REQUEST

(PUD1302) Oakcrest Homes Inc., 7683 Cottonwood, is requesting to have a planned unit development with 100 units of intermediate care and 20 units of assisted, along with an accessory building, parking areas and various amenities, on a parcel of land described as P.P. # 70-14-14-200-063, located at 8001 Cottonwood Dr. Oakcrest acquired two additional parcels along Cottonwood and those parcels have been combined with the larger overall parcel. In addition, the southwest property of the Allen Springs parcel has been combined with the Oakcrest parcel.

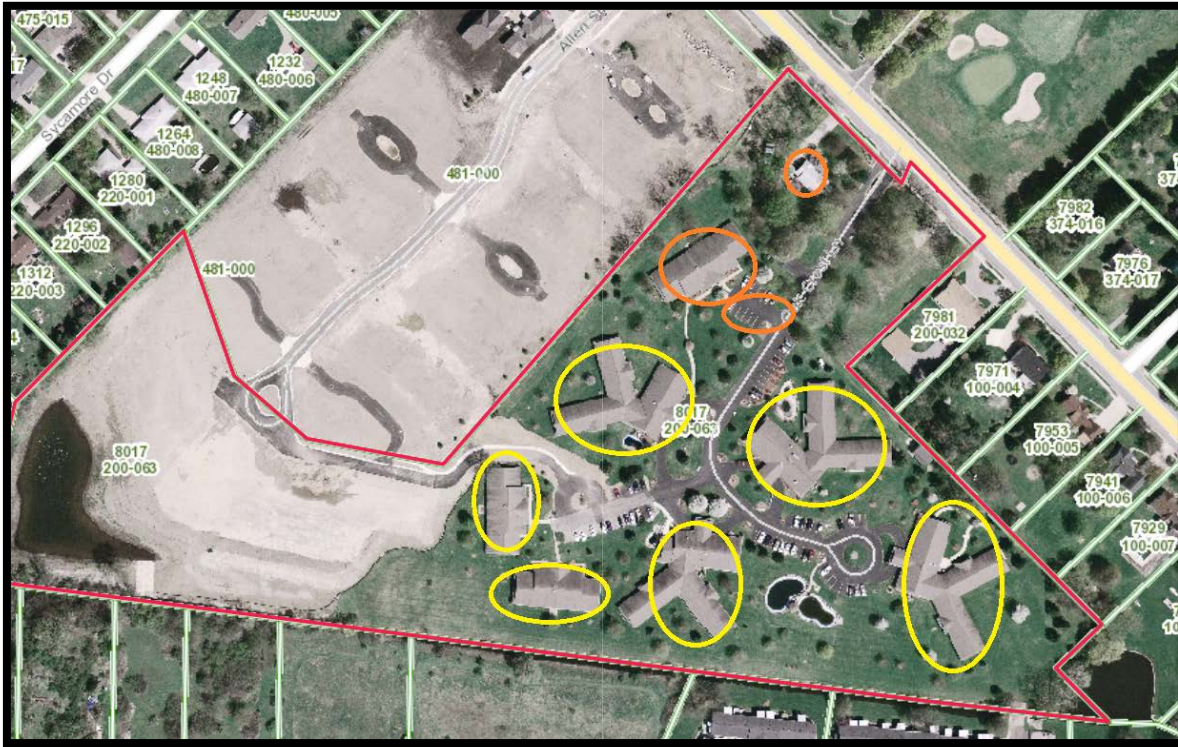
The site and use currently exist as shown on the picture below. The buildings circled in yellow are proposed to remain. The two buildings and paved parking lot circled in orange are proposed to be demolished. One new building with 20 units of assisted living is proposed to be constructed and one new building for accessory uses (such as storage) are proposed to be constructed in the area where the structures are to be demolished.
